# MONITORING YEAR 5 ANNUAL REPORT

## OWL'S DEN MITIGATION SITE

RE: Owl's Den Mitigation Site-Year 5 Monitoring Report  
Final Submittal for DMS  
Contract Number 005150, DMS# 95808  
Catawba River Basin – CU# 03050102; Lincoln County, NC  
*Providing mitigation for CU#03050103 (Catawba ESA)*

Wildlands Engineering, Inc. (Wildlands) has reviewed the Division of Mitigation Services (DMS) comments and observations from the Owl's Den Mitigation Site Draft Year 5 Monitoring Report. The report text has been revised for the final draft to reflect the most current condition of the site. The following are your comments and observations from the report and are noted in **Bold**. Wildlands' response to those comments are noted in *Italics*.

Figure 3.1 Integrated Current Condition Plan View (Sheet 1 of 3)  
 Owl's Den Mitigation Site  
 DMS Project No. 95808  
 Monitoring Year 5 - 2020  
 Lincoln County, NC

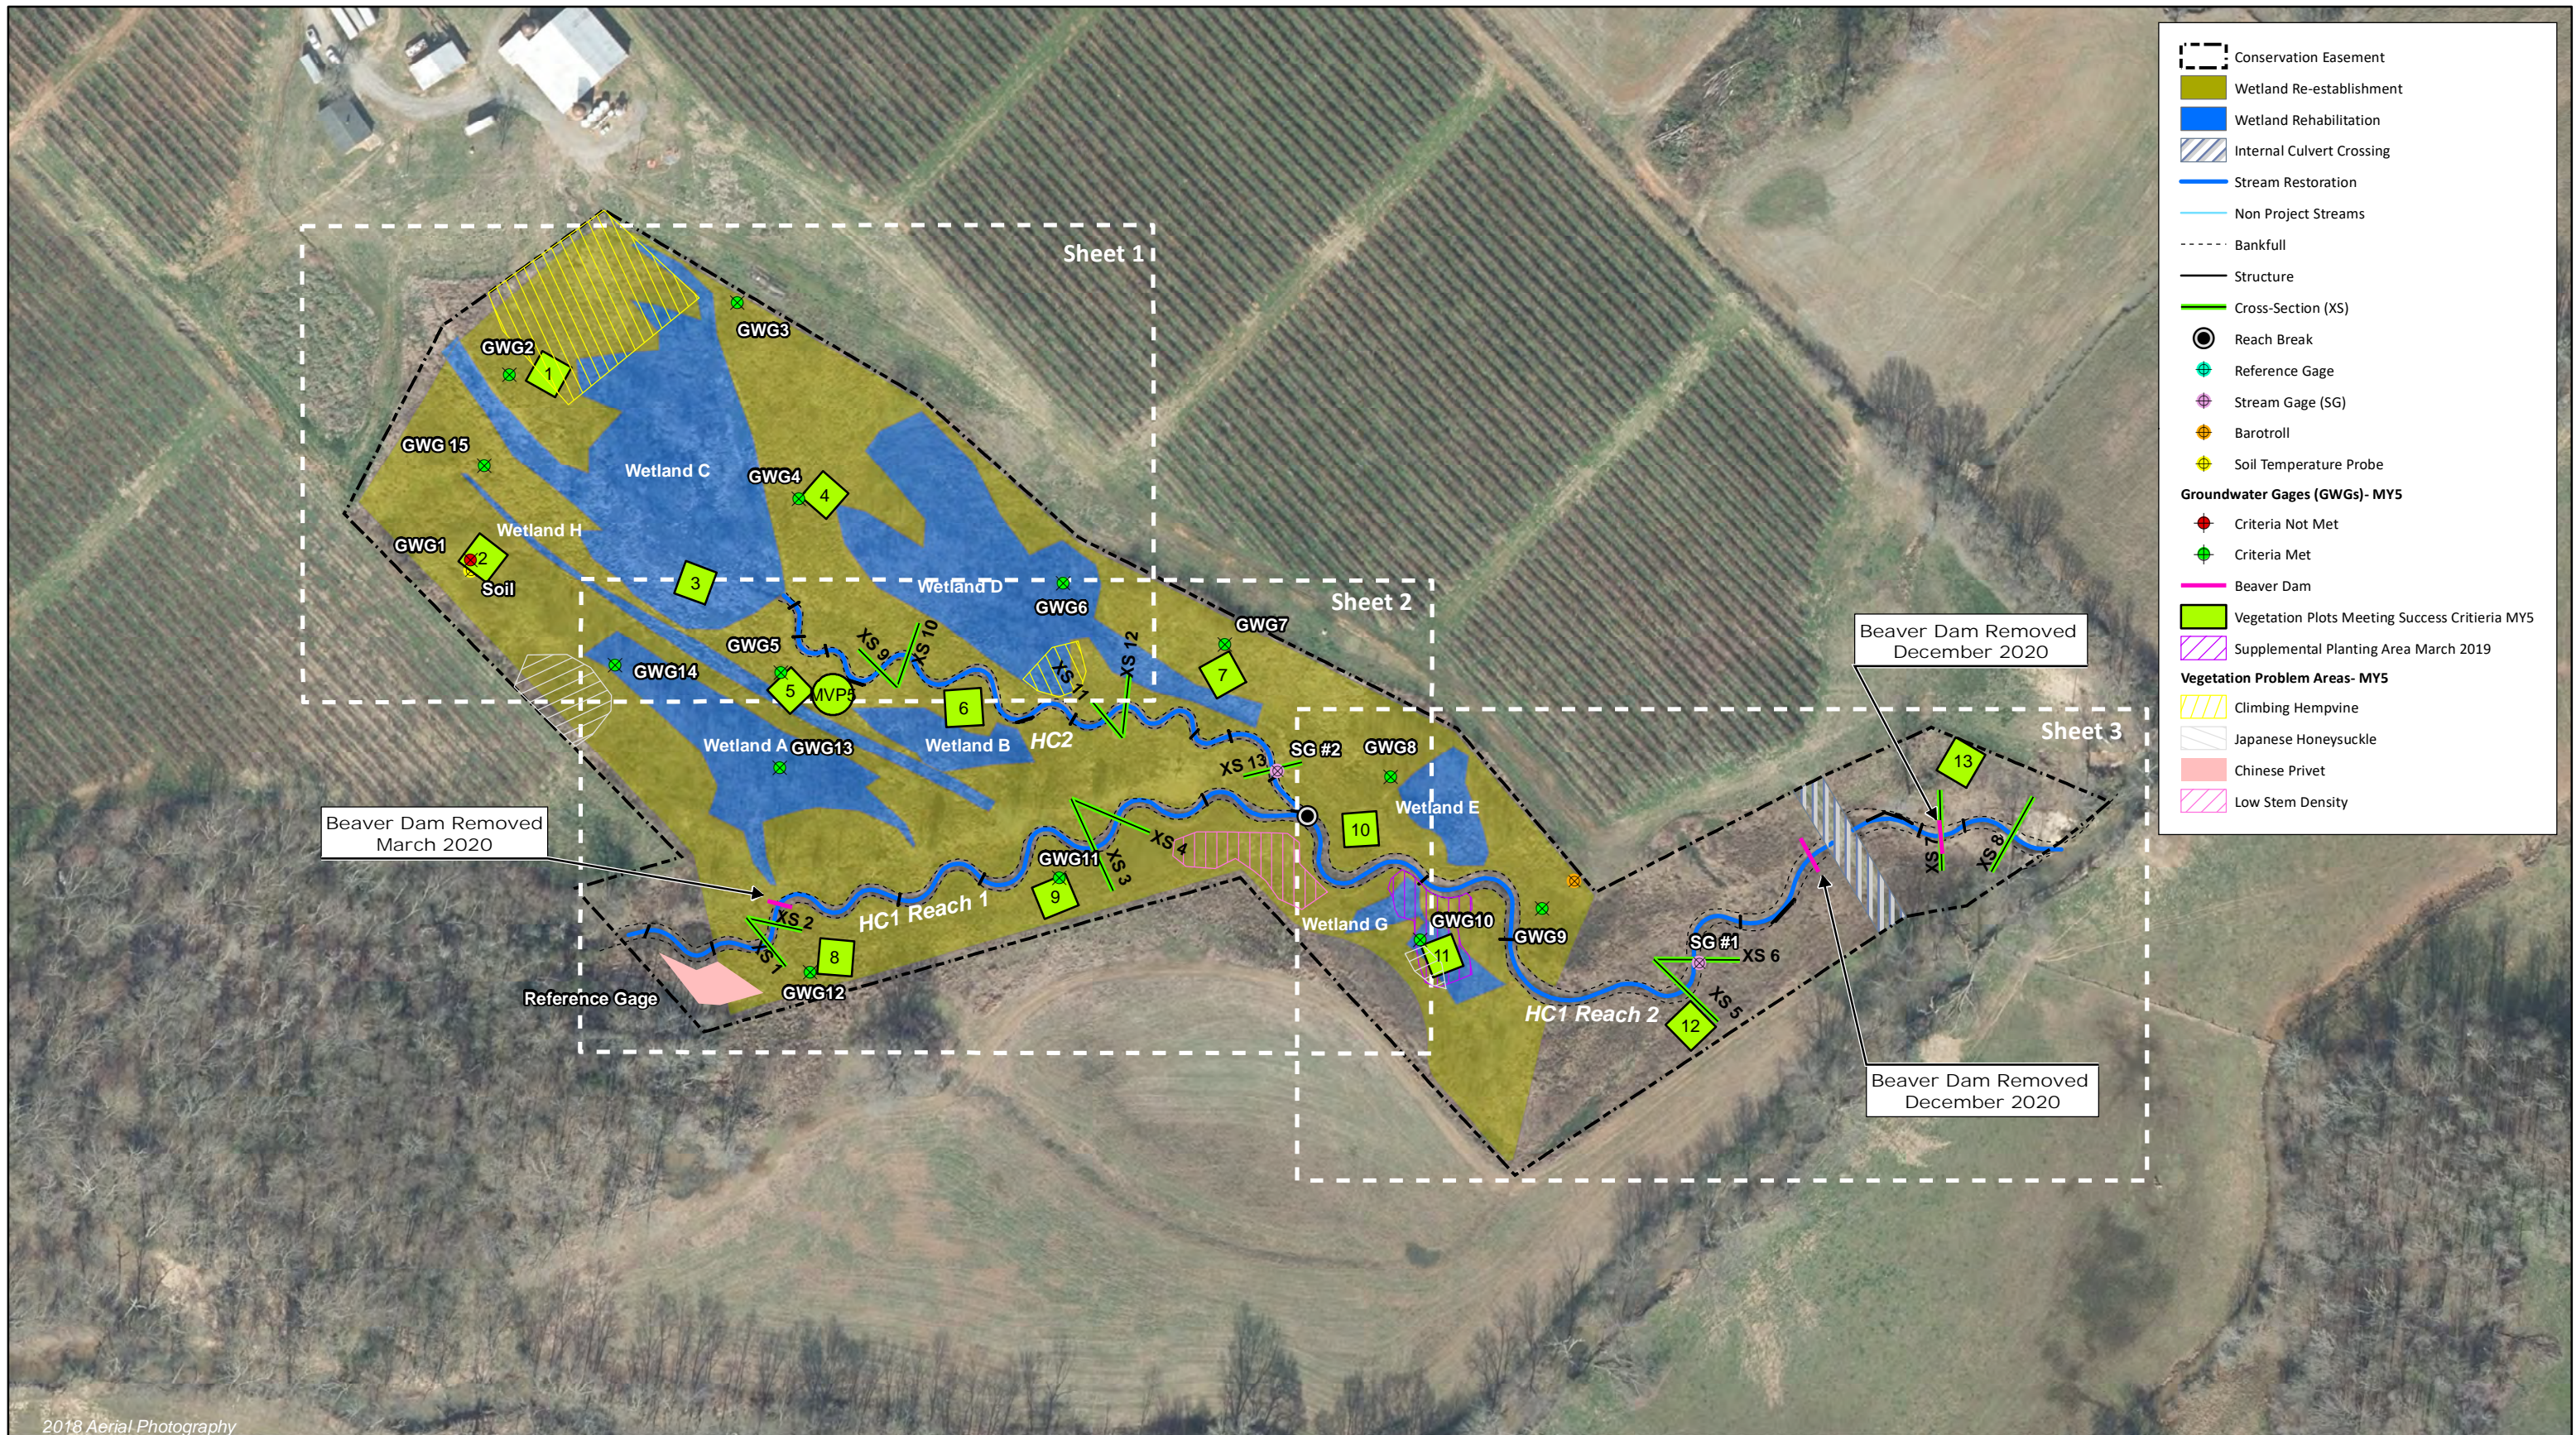
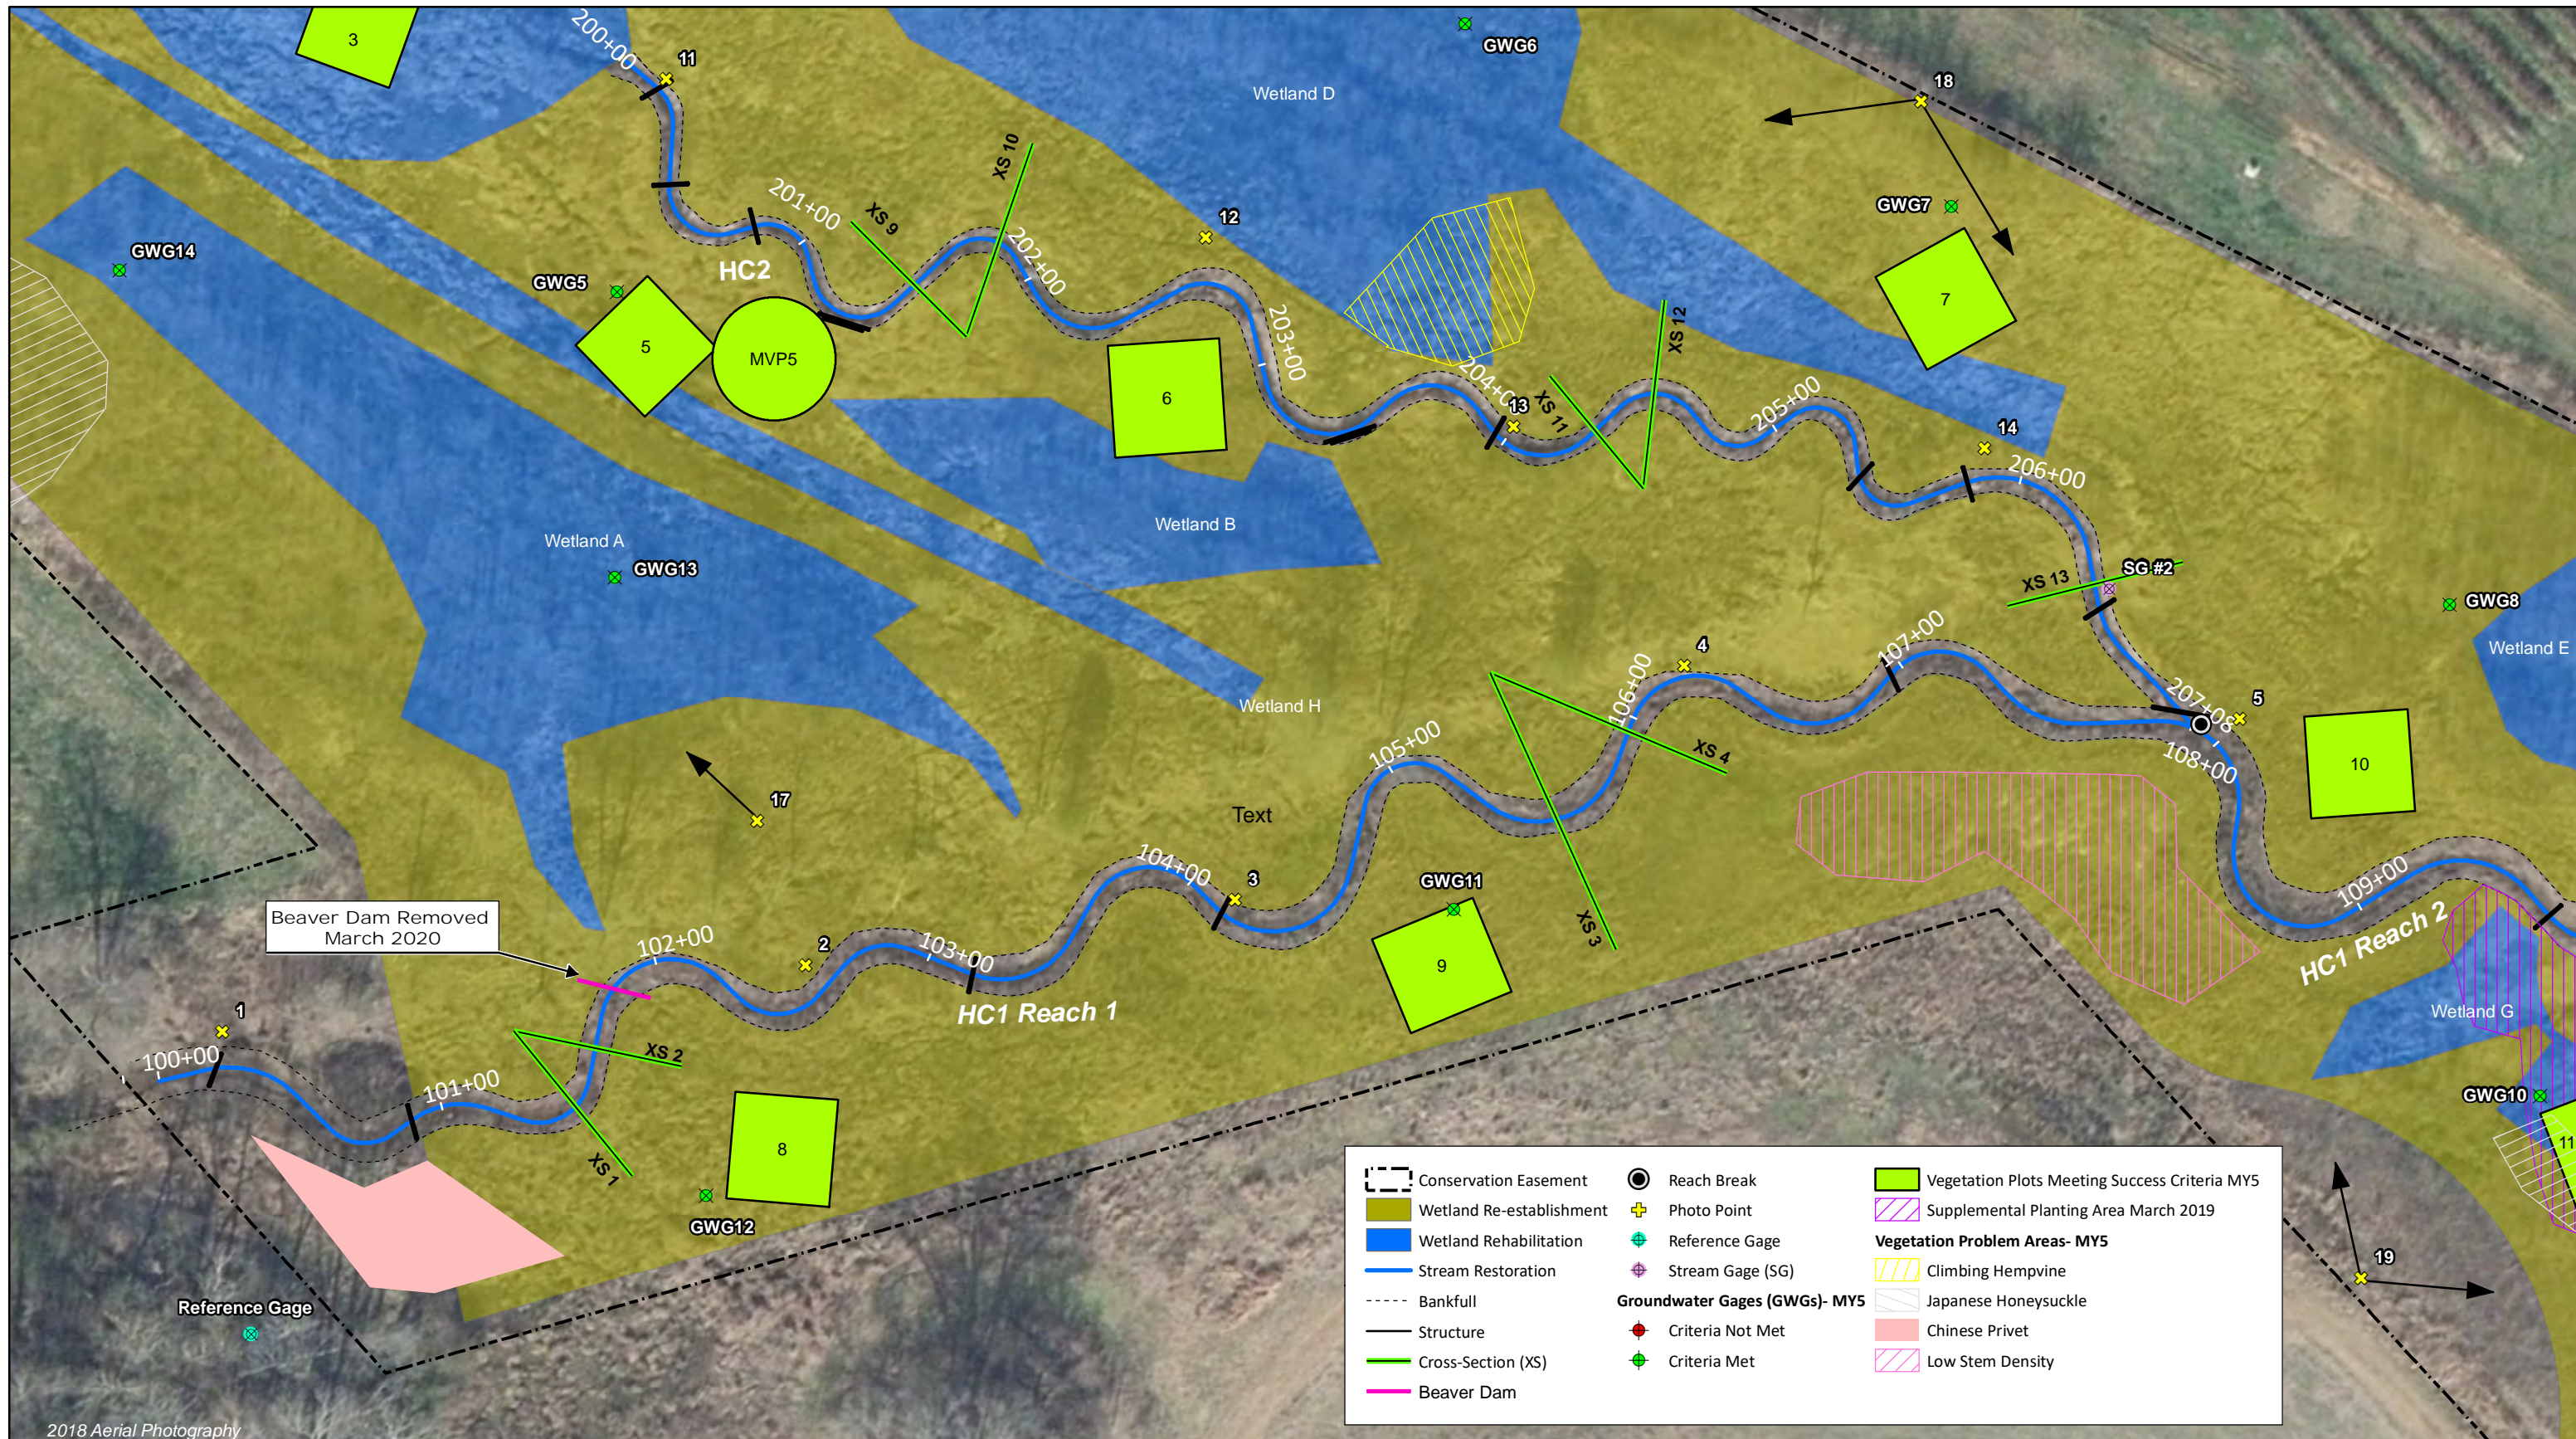
**DMS Comment: Section 1.2.5 - Areas of Concern/Adaptive Management Plan: Please update this section to indicate when these dams were removed and beaver trapped or provide a scheduled removal/ trapping date/s. DMS recommends removing beaver and beaver dams as soon as possible to avoid potential irregular monitoring data, project damage and additional project maintenance.**

*Wildlands Response: The report and figures have been updated to reflect that the dams were removed in early December of 2020. Wildlands is currently monitoring for continued beaver activity and will address in Q1 of MY6, if needed.*
